Errata

October, 1966 (Vol. 3, No. 4)

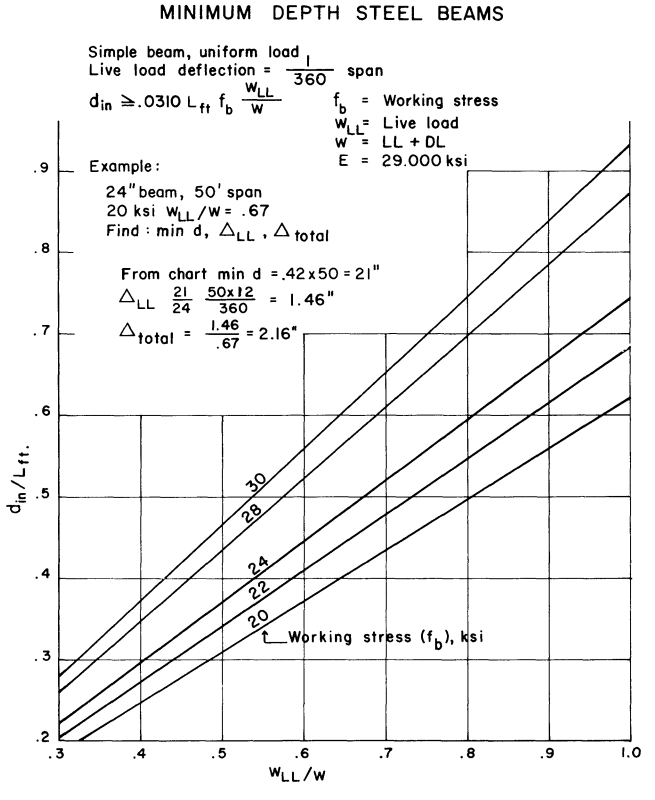
In Adolph A. Marrone's discussion of the April, 1966, paper by George Froyton, identification of the working stress values was inadvertently omitted from the curves in the chart entitled "Minimum Depth Steel Beams." These values have been added to the chart, and the corrected chart is reproduced below:
